NET-264-02 P, Revision 3, "Criticality Analysis of the Peach Bottom Spent Fuel Racks for GNF 2 Fuel with Boraflex Panel Degradation Projected to May 2010" (Non-Proprietary Version)

**Response to Request for Additional Information – Revision to
Technical Specification 4.3.1.1.a Concerning k-infinity, Revision 1
(Non-Proprietary Version)**

Response to Request for Additional Information – Revision to
Technical Specification 4.3.1.1.a Concerning k-infinity

Figure 3-5: Predicted Boron Carbide Loss through May 1, 2010 in the Peach Bottom Spent Fuel Storage Racks

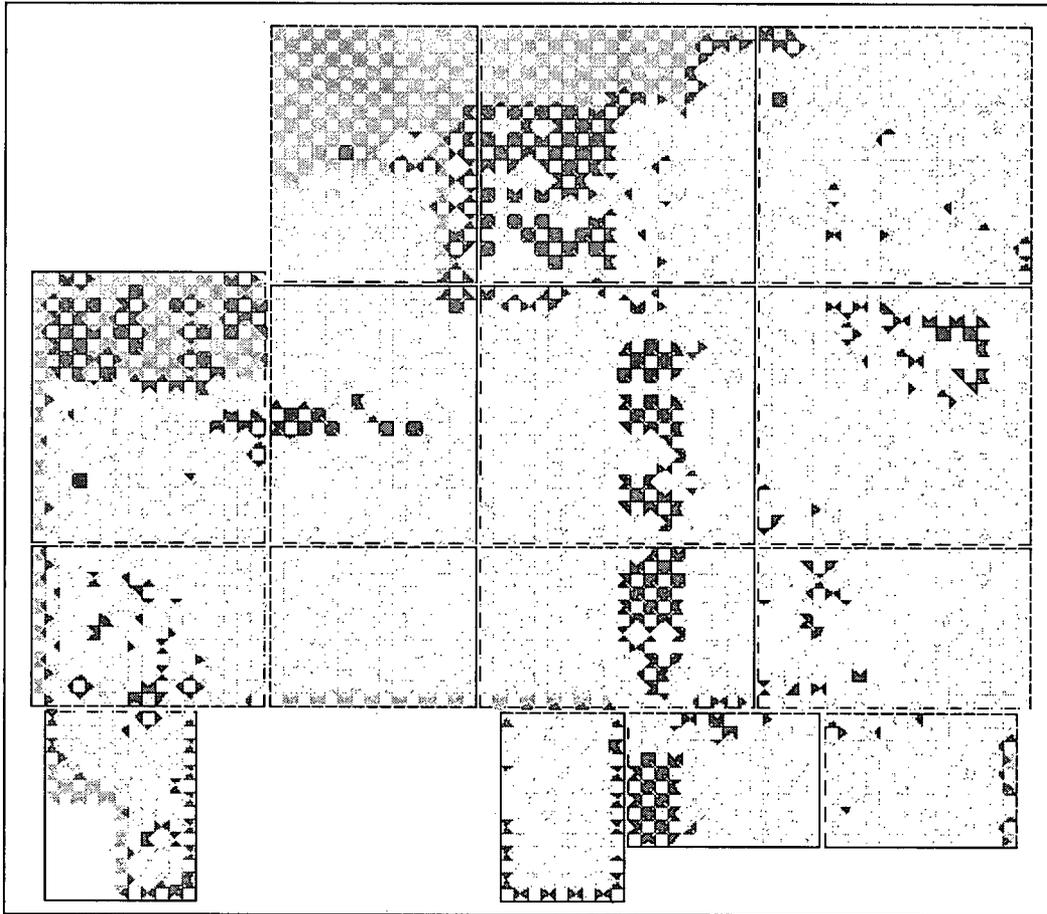
An "average panel boron carbide loss" is projected in NET-264-02 and converted into an estimated uniform Boraflex panel thinning for the entire SFP. However, Figure 3-5 indicates that a large number of storage cells will have a projected individual "panel boron carbide loss" []. These storage cells are collocated, [] These localized circumstances are not addressed. Please provide information that addresses the localized effects of collocated storage cells and the localized k_{eff} values relative to the estimated uniform Boraflex panel thinning for the entire SFP.

Response:

KENO V.a models of the limiting modules that contain arrays of cells with high loss panels [($> \text{---} \%$)] were also analyzed to verify that the reactivity effect of collocated panels did not exceed the reference case k_{∞} . Modules 7 (peripheral) and 12 (central) contain the largest arrays of high loss panels. These modules were modeled with 5x7 and 5x10 arrays of high loss panels [($\text{---} \%$)] and surrounded by rows of cells conservatively assumed to be at the highest loss that bounded adjacent cells (i.e., the highest loss for a block of cells was assumed for all
